western peripherals

MEMORANDUM

SUBJECT: Product Information Bulletins:

Enclosed is a set of Product Information Bulletins that apply to your Model TC-120 Data General Magnetic Tape Controller. Most of these changes are already incorporated in your present board, and are being sent in a complete set merely as a reference.

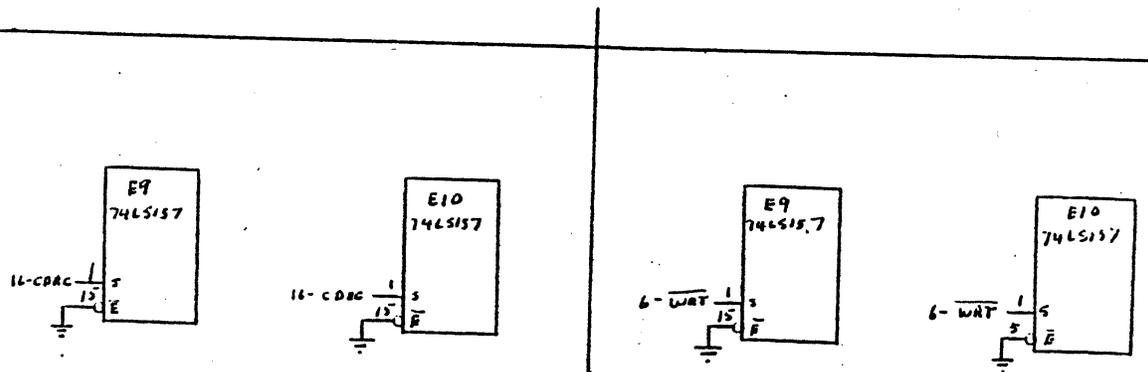
This change improves the gating into the data shift registers.

1. Cut etch on solder side at E9, pin 1 (cut beyond feed through)
2. Add wire from E7B, pin 6 to E9, pin 1
3. Re-label board from H to K
4. Schematics - Sheet 14
E-9 and E-10, pin 1 input is now the term \overline{WRT} from sheet 6
5. Maintain a copy of this document with affected controllers

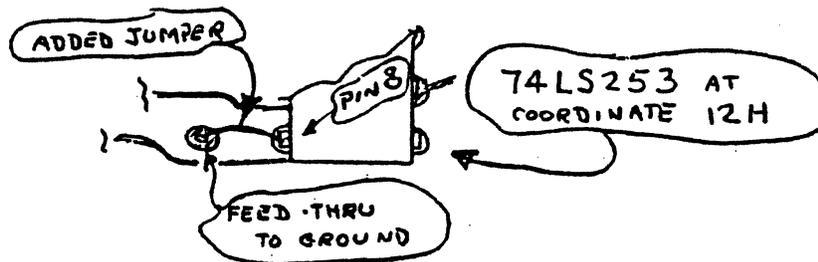
These changes reduce noise that may exist because of component location.

Add a jumper from 12H, pin 8 (ground) to the ground bus at the adjacent feed-thru as shown.

Cut the etch on the solder side of the board at the feed-thru next to 2N pin 5

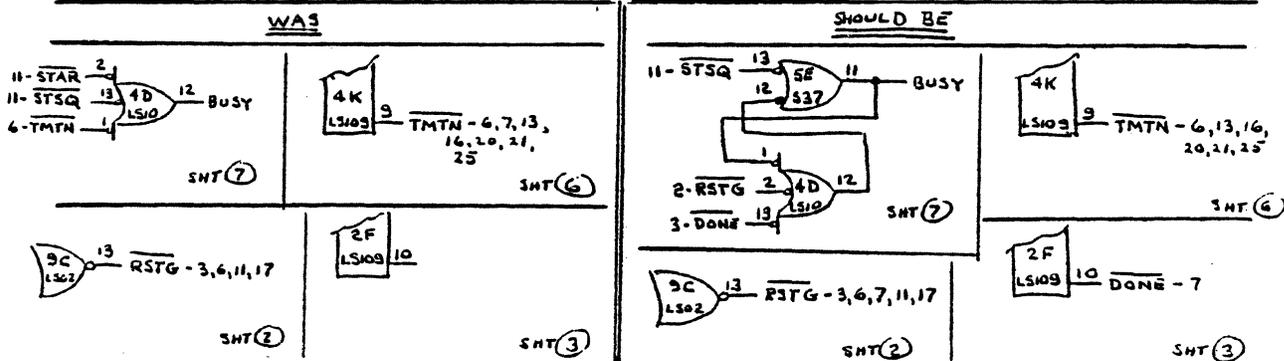
This bulletin eliminates a race condition in the SELB logic (busy)

1. On component side, cut D4, pin 13
2. On component side, cut D4, pin 2
3. On solder side, cut D4, pin 1
4. On solder side, cut D4, pin 12
5. On solder side, cut D4, pin 13
6. Add jumper from F2, pin 13 to D4, pin 13
7. Add jumper from E5, pin 11 to D4, pin 1
8. Add jumper from E5, pin 11 to feed through near 4D, pin 7
9. Add jumper from F5, pin 4 to D4, pin 2
10. Add jumper from E5, pin 13 to feed through near D4, pin 13
11. Add jumper from C4, pin 9 to feed through near D4, pin 13
12. Add jumper from E5, pin 12 to D4, pin 12
13. Re-label 120024 to revision N
120025 to revision B
14. Schematic
15. CHANGE THE SCHEMATIC AS SHOWN BELOW:

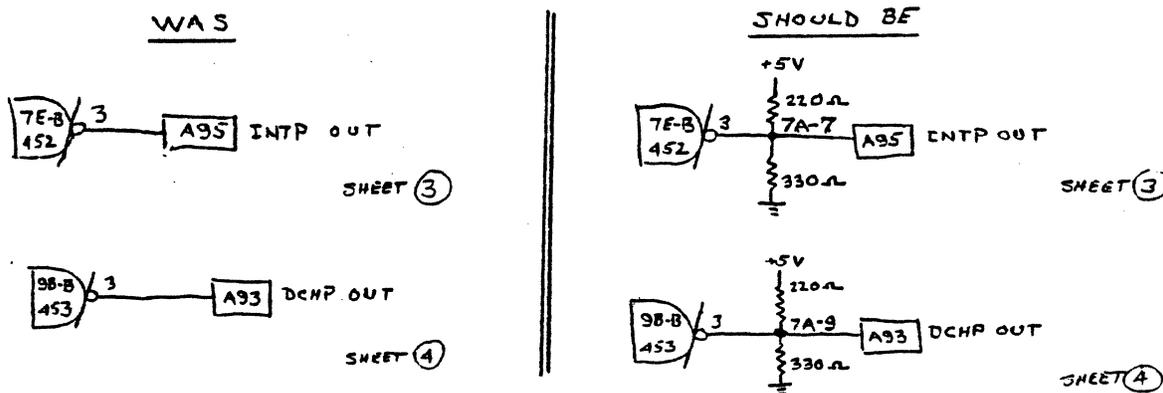
This change adds termination networks to the INTP OUT and the DCHP OUT signals.

Change schematic 120016 in the Logic Manual as follows:

TITLE/DESCRIPTION ERROR REPORTING IMPROVEMENT			NUMBER 12012
PRODUCT LINE TAPE CONTROLLER	MODEL AFFECTED TC-120	EFFECTIVE DATE 4-22-77	REFERENCE ECO # 176

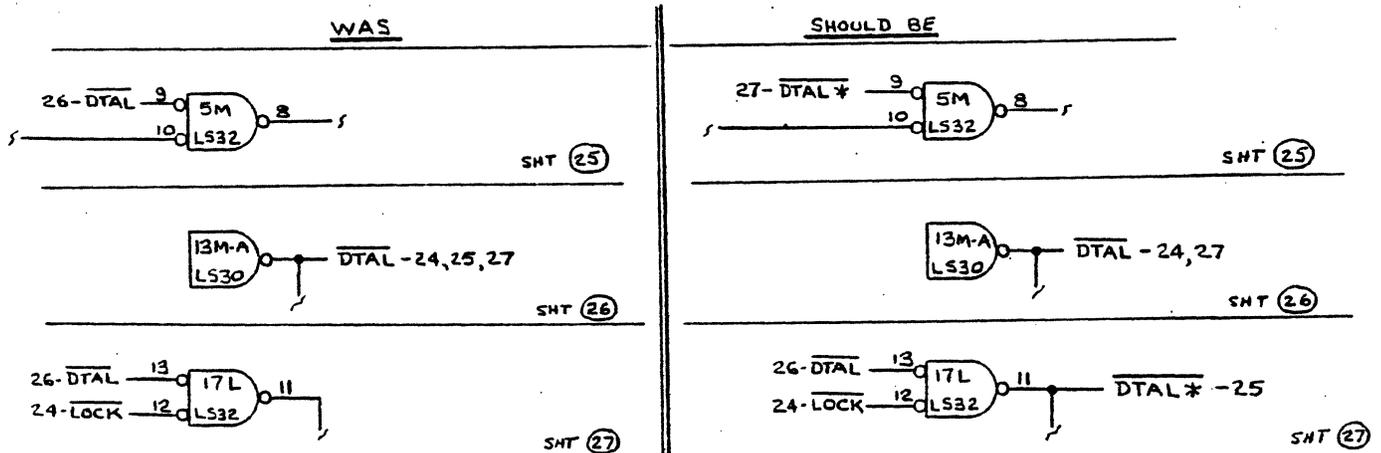
Parity errors may be incorrectly reported at load point in the PE mode.

On the component side of the board, cut the etch coming from 5M pin 9 where it comes out from under 5M between pins 6 and 7.

Add a jumper on the component side of the board from 4K pin 5 to 5M pin 9. (Note: existing wire on 4K pin 5 was installed at revision M).

TITLE/DESCRIPTION DATA RELIABILITY IMPROVEMENT			NUMBER 12013
PRODUCT LINE TAPE CONTROLLER	MODEL AFFECTED TC-120 & TC-128	EFFECTIVE DATE 7-19-77	REFERENCE ECO # 195,200

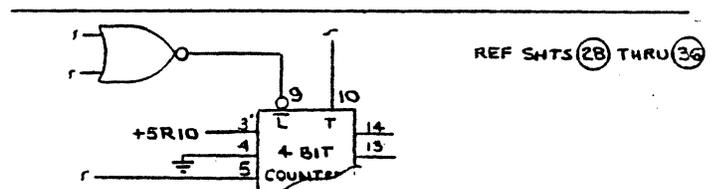
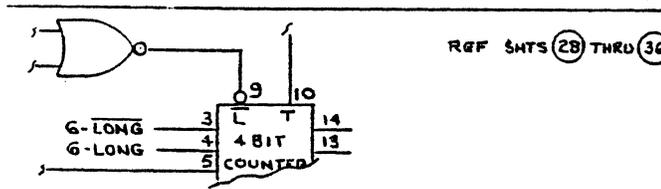
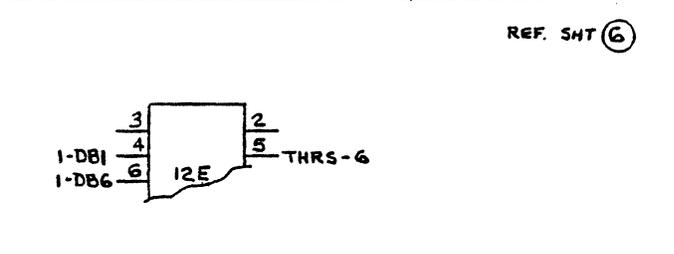
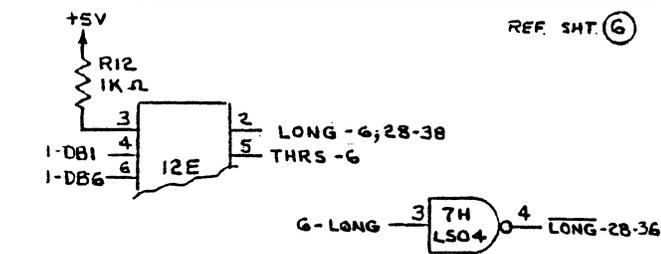
Intermittent parity errors are detected, especially at higher data rates.

This change decreases the susceptibility to read errors caused by jitter by increasing read window timing to 69% of the bit cell.

Change schematic I20016 in the Logic Manual as follows:

WIRING DIAGRAM
(REF ONLY)
120034

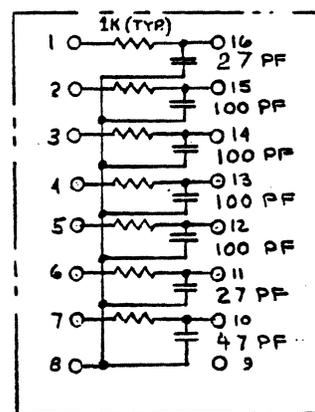
TITLE/DESCRIPTION REDUCE BUS NOISE AND IMPROVE POSTAMBLE DETECTION			NUMBER 12014
PRODUCT LINE TAPE CONTROLLER	MODEL AFFECTED TC-120 & TC-128	EFFECTIVE DATE 1-2-78	REFERENCE ECO # 259, 260
DISPOSITION <input checked="" type="checkbox"/> IMPROVEMENT <input checked="" type="checkbox"/> RETROFIT ON FAILURE <input type="checkbox"/> RECOMMEND MANDATORY <input type="checkbox"/> INFORMATION ONLY		EFFECTIVITY This change updates Assembly Number: 120024 from Rev. V to Rev. W 120025 from Rev. G to Rev. H	
<u>CHANGE DESCRIPTION</u> This change corrects the implementation of bad post-amble detection and improves the timing of resynchronizing circuits to assure correct data is transferred to the processor. In addition, this change improves the rejection of noise on the I/O bus.			
<u>CHANGE PROCEDURE</u> Remove the controller board from the equipment and perform the following modifications: Desolder and remove the filter chip (part #120005) at location B7 and install filter header (part #120034) at location B7. Cut the etch on the component side of the board at the following locations: From 7B pin 1 From 6B pin 2 to 7B pin 16 where it passes between 7B pins 1 and 2 From 10F pin 10 where it comes out between 10F pins 5 and 6 From 7P pin 15 where it comes out between 7P pins 1 and 2 Remove any jumper connecting 7C pins 12 and 13 Add jumpers at the following locations: From 6B pin 1 to 6B pin 2 From 7P pin 11 to 7P pin 15 From 10F pin 9 to 10F pin 10 Install a 74S109 at locations 1B and 2F Mark the updated revision level on the board near the part number. Visually inspect all changes and use the continuity tester (or ohmmeter) to check etch cuts and jumpers. Watch for shorts to adjacent pins at each jumper connection. Reinstall the controller and perform diagnostic and operational checks. Keep a copy of this change with affected systems.

Quantity	1
Description	Filter header
Part #	120034
Reference	B7
Quantity	2
Description	IC
Part #	74S109
Reference	1B, 2F

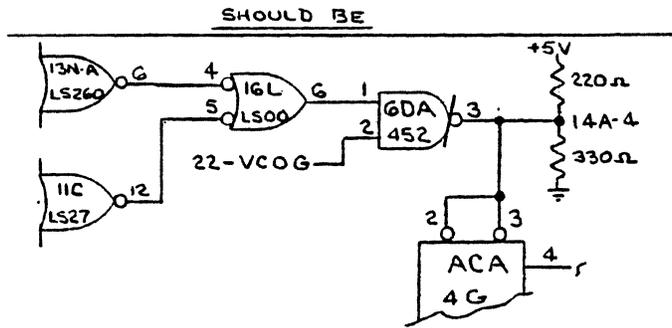
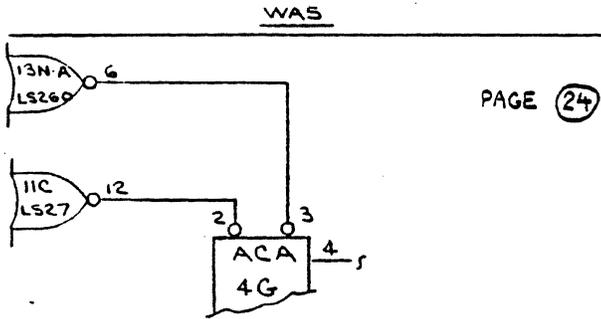
TITLE/DESCRIPTION PERFORMANCE IMPROVEMENT - 125 IPS			NUMBER 12015
PRODUCT LINE TAPE CONTROLLER	MODEL AFFECTED TC-120 & TC-128	EFFECTIVE DATE 8-2-78	REFERENCE ECO # 375
DISPOSITION <input checked="" type="checkbox"/> IMPROVEMENT <input checked="" type="checkbox"/> RETROFIT ON FAILURE <input type="checkbox"/> RECOMMEND MANDATORY <input type="checkbox"/> INFORMATION ONLY		EFFECTIVITY This change updates Assembly Number: 120024 from Rev. X to Rev. Y 120025 from Rev. K to Rev. L SN 879 and below are affected.	
<u>CHANGE PROCEDURE</u>			
Remove the controller from the equipment and perform the following modifications:			
Repair the etch on the component side of the board at the feed-thru by location 17C pin 16 that connects to 17C pin 15 on the solder side			
Remove the following jumpers:			
<p style="margin-left: 40px;">From 16L pin 6 to the feed-thru by location 17C pin 16 that connects to 17C pin 15 on the solder side</p> <p style="margin-left: 40px;">From 16L pin 4 to 17J pin 1</p> <p style="margin-left: 40px;">From 16L pin 5 to 5E pin 10</p>

Change schematic I20016 in the Logic Manual as follows:

TITLE/DESCRIPTION GROUND NOISE REDUCTION IMPROVEMENT			NUMBER 12016
---	--	--	-----------------

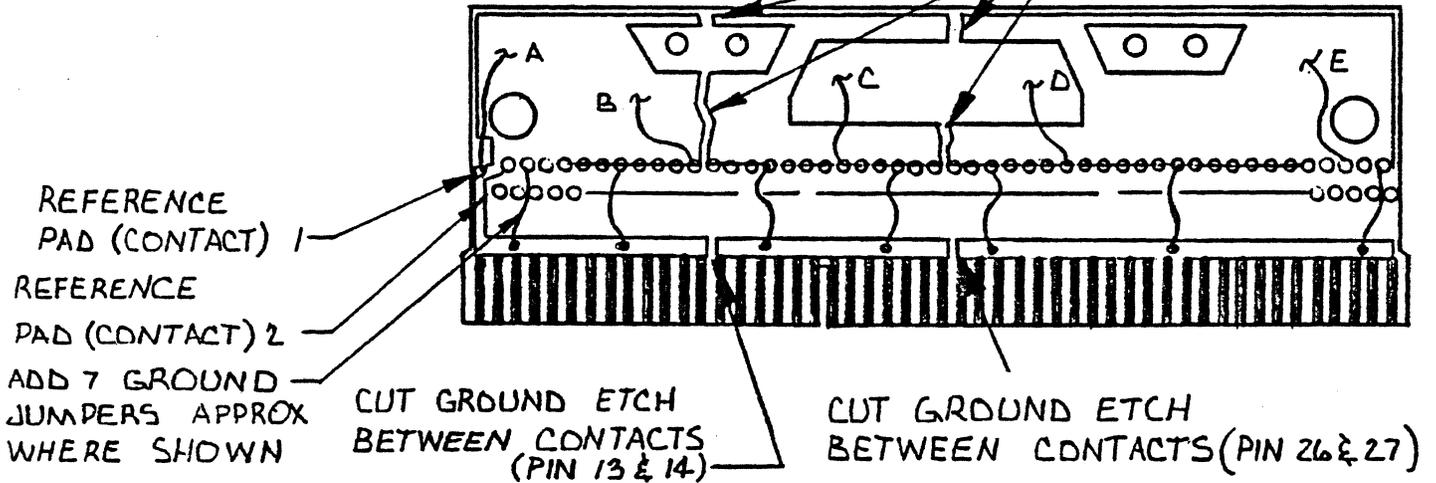
Reduce noise on ground by isolating grounds for read, write, and control signals.

REWORK THE CABLE ASSY BY MAKING INDICATED ETCH CUTS ON THE PWB (9) AND REWIRE THE GROUNDS AS SHOWN ON THE WIRING CHART.

CUT GROUND ETCH APPROX WHERE SHOWN 4 PLACES FRONT & 3 PLACES FAR SIDE.

JUMPER FROM	TO
A	NOVA "B" 1
B	NOVA "B" 2
C	NOVA "B" 50
D	NOVA "A" 79
E	NOVA "A" 80
